RSN: 1902240 | PERMIT# 25-2534172 -LT (PLAN REVISION TO PERMIT# 25-2513934 -CM, RSN:1881854)

PLAN REVISION TO PERMIT# 25-2513934 -CM, RSN:1881854

City of Aurora Building Division
Reviewed for Code Compliance
Approved as Noted: Robert Lowman
Date: Jun 06, 2025
2021 INTERNATIONAL CODES & 2023 NEC

JOB 24464.0000
DATE 05.30.25
SHEET
E00-01

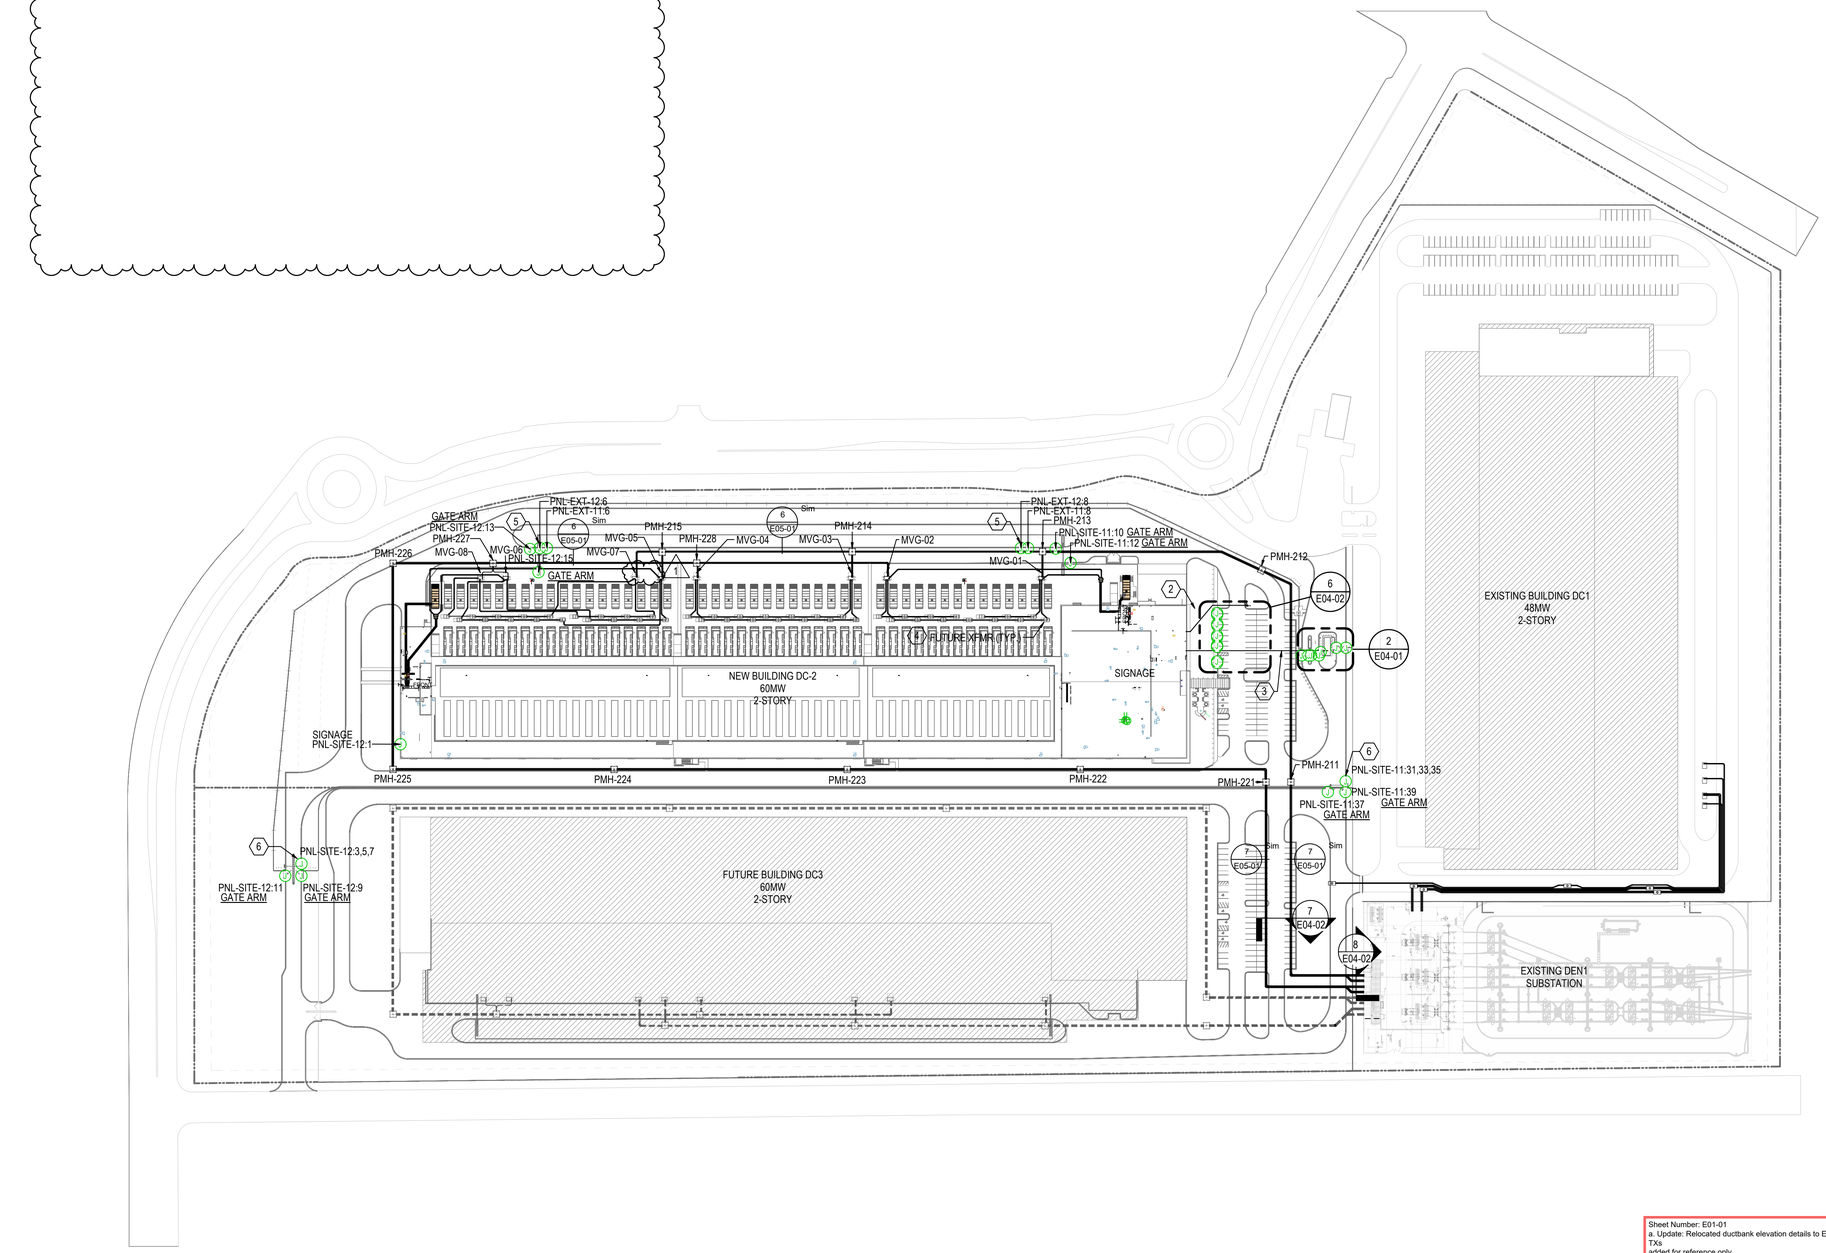
Sheet Number: E00-01
a. Update: Revised sheet list specific to Foundations Permit IFP, minor revisions to
version matrix details, select lighting control symbols

JOB 24464.0000
DATE 05.30.25
SHEET E01-01

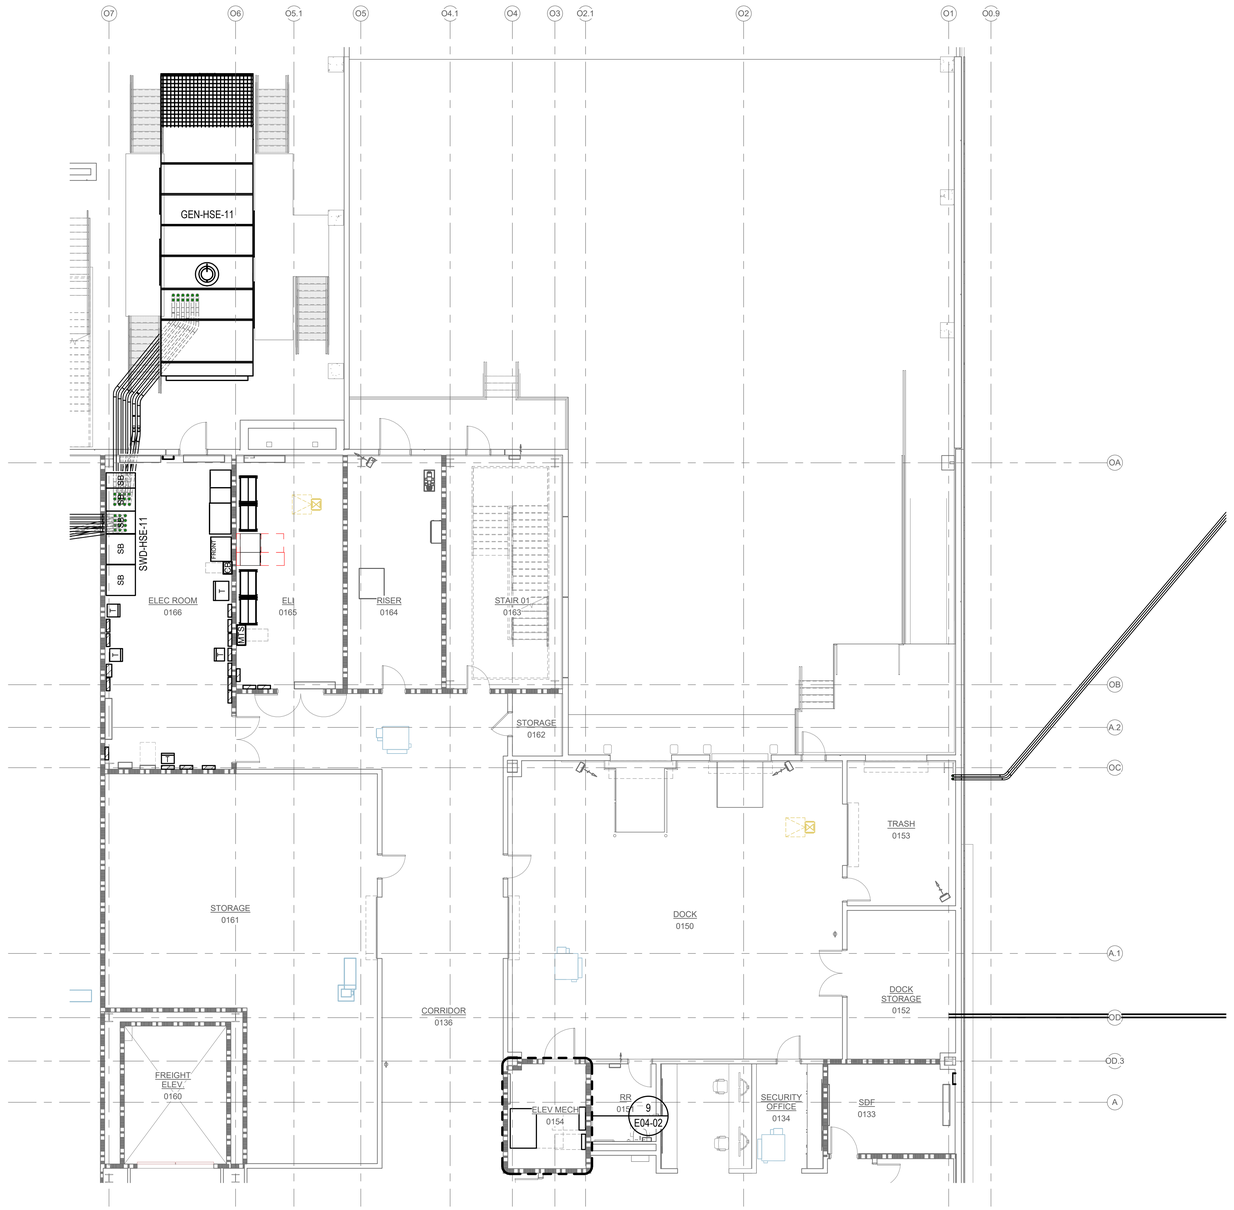
Sheet Number: E01-01
a. Update: Relocated ductbank elevation details to E04-02. Future generators/ TXs
added for reference only.

JOB 24464.0000
DATE 05.30.25
SHEET E04-01

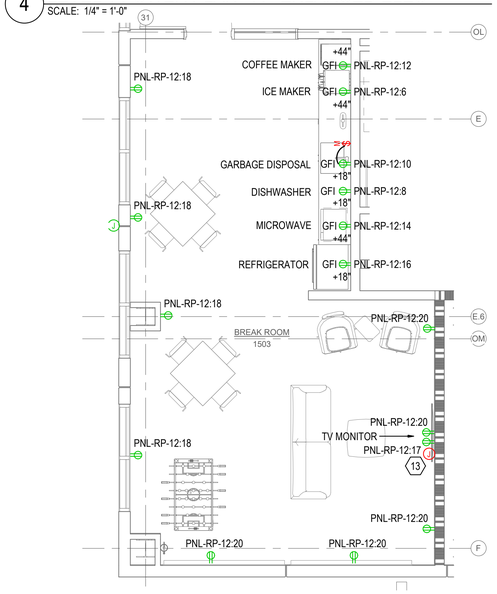
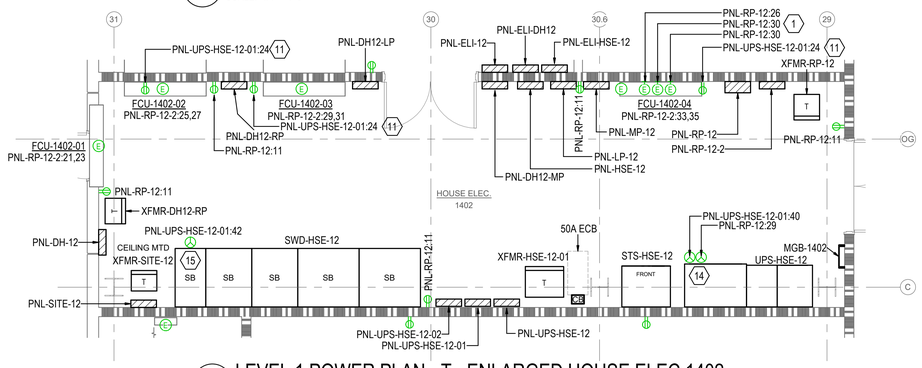
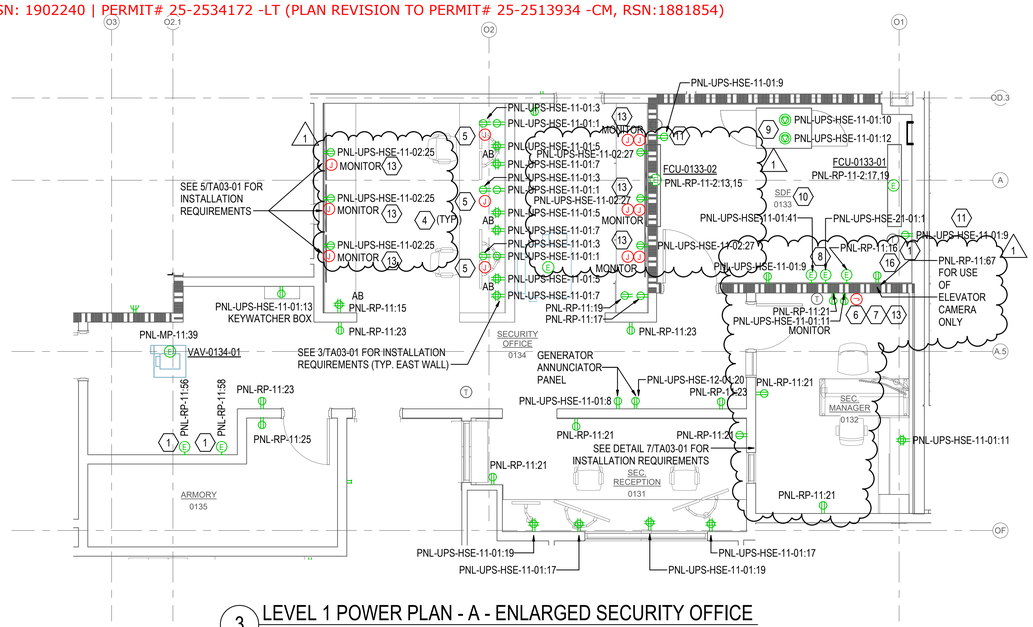
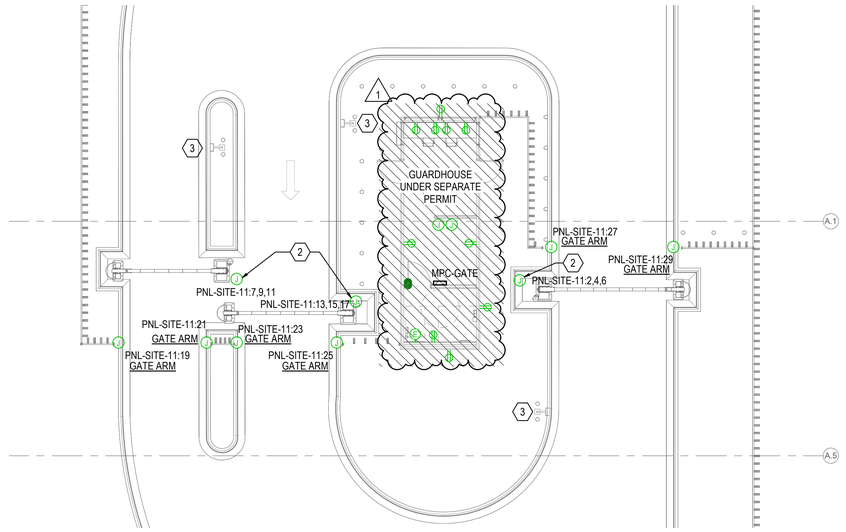
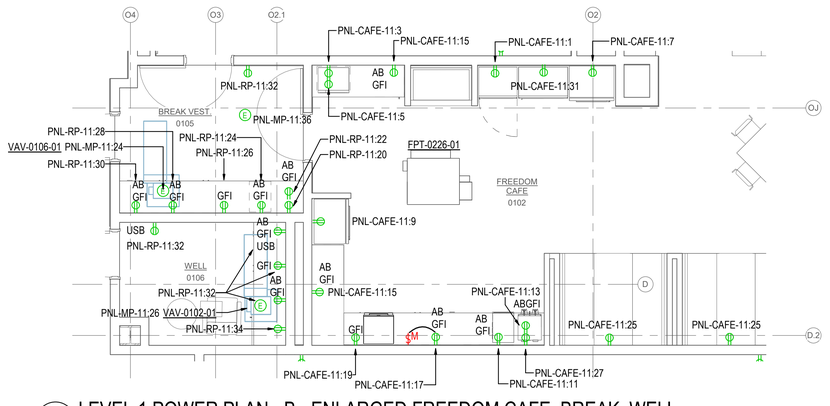
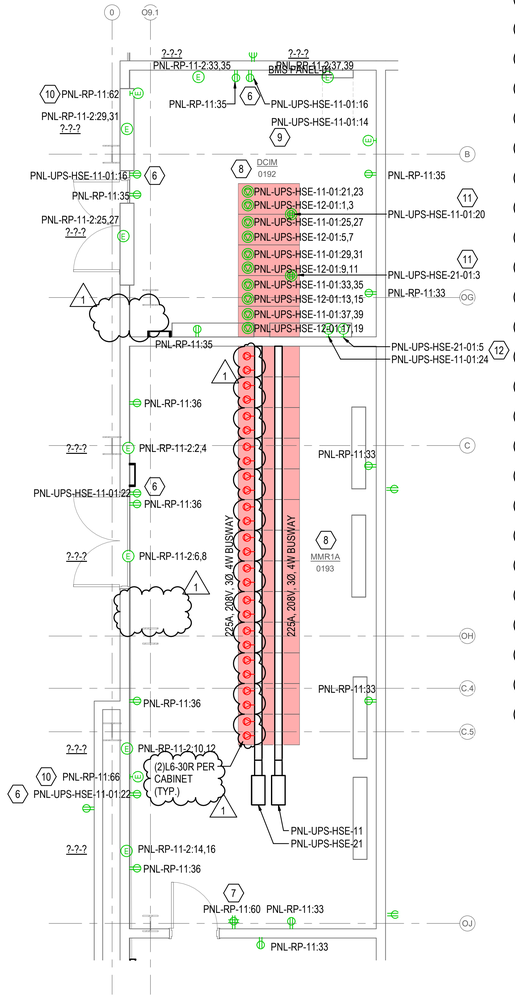
Sheet Number: E04-01, E04-02
a. Update: Added/updated enlarged plans House Elec 1402, Enlarged Elec A, and
Enlarged Security Office A, Enlarged Elev. Room A, Enlarged Elev. Room B.
Relocated ductbank section views from sheet E01-01.

JOB 24464.0000
DATE 05.30.25
SHEET E05-01

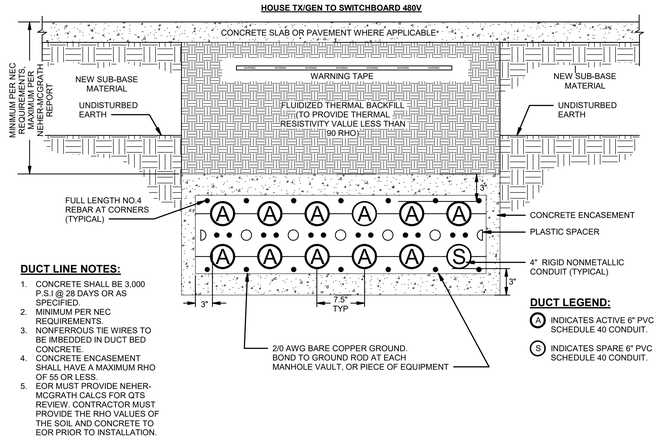
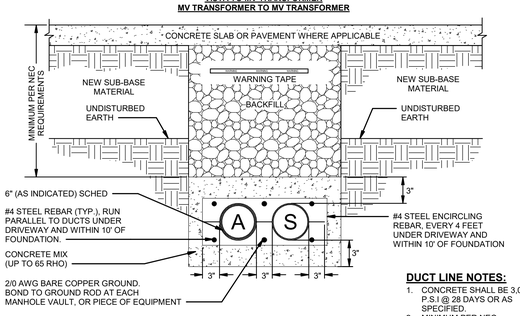
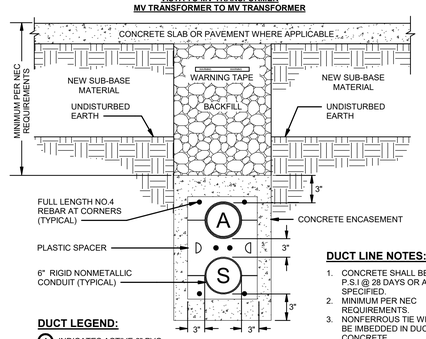
Sheet Number: E05-01
a. Update: Revised underground ductbank details to align with latest Neher-McGrath report.

JOB 24464.0000
DATE 05.30.25
SHEET E06-01

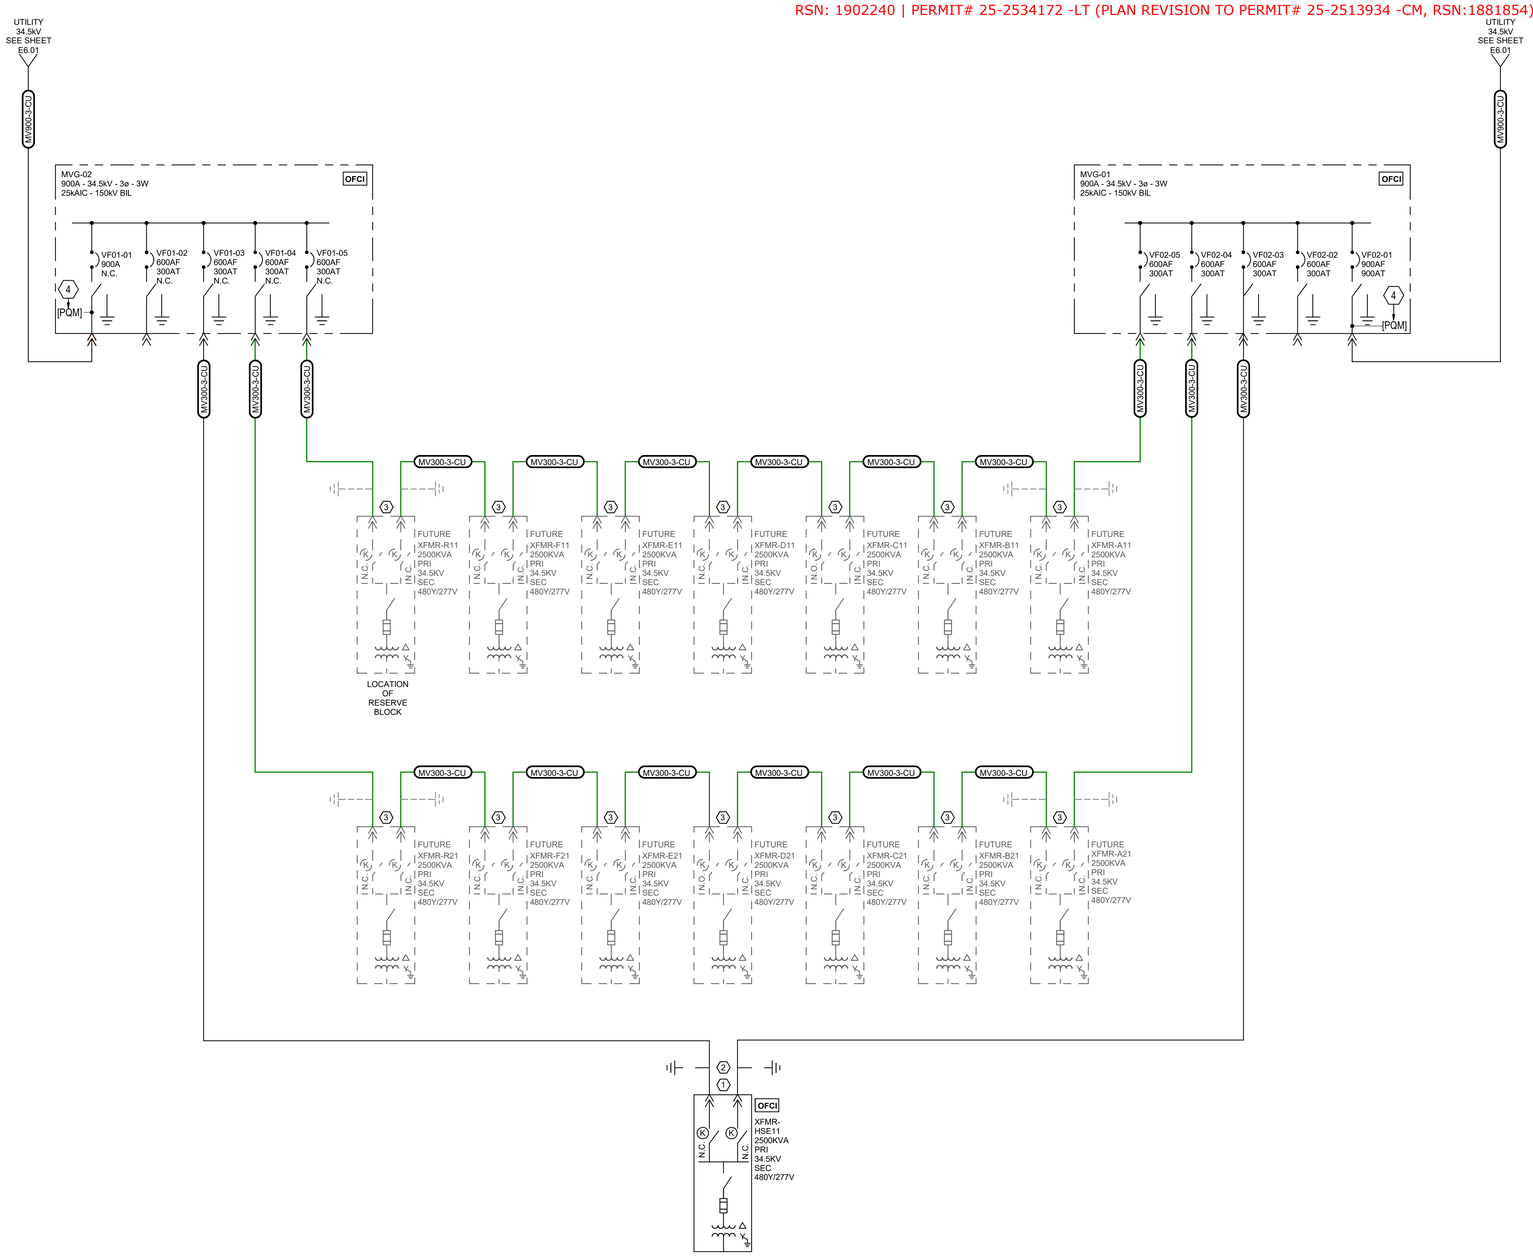
Sheet Number: E06-01, E06-02, E06-03, E06-04, E06-05
a. Update: Added sheet note D clarifying paid requirements. Clarified where conduit
and wire vs. Conduit only is to be installed.

JOB 24464.0000
DATE 05.30.25
SHEET E06-02

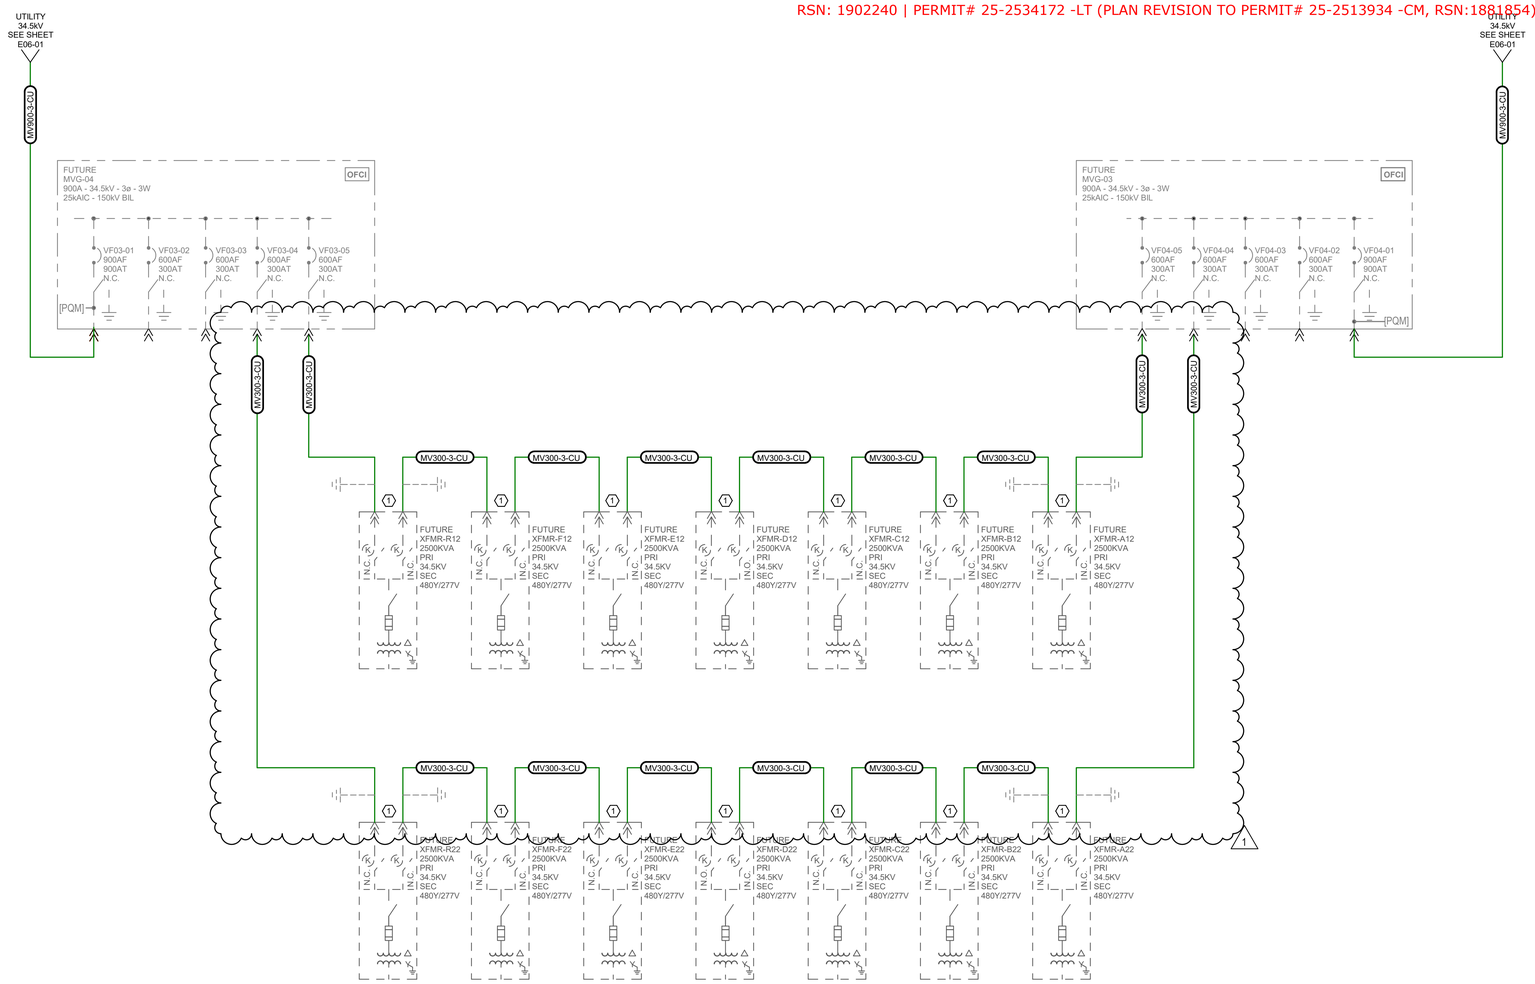
Sheet Number: E06-01, E06-02, E06-03, E06-04, E06-05
a. Update: Added sheet note D clarifying pad requirements. Clarified where conduit
and wire vs. Conduit only is to be installed.
